Performance Bulletin

December 2007

New Circuit Board on 3200NT

New 3200NT Circuit Board
(Not Actual Size)

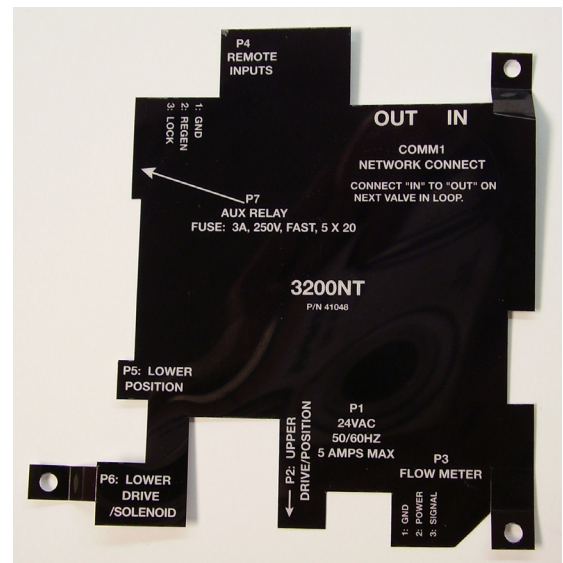
Effective as a running change as inventory depletes, the 3200NT timers will begin the transition to a new circuit board. The new board does not affect any of the current functions. The most noticeable difference will be in the removal of the Mylar® cover on the back of the timer. Since the Mylar® cover will be removed, the new circuit board has the text imprinted on it. This change is being made due to vendor discontinuation of components on the older circuit boards.
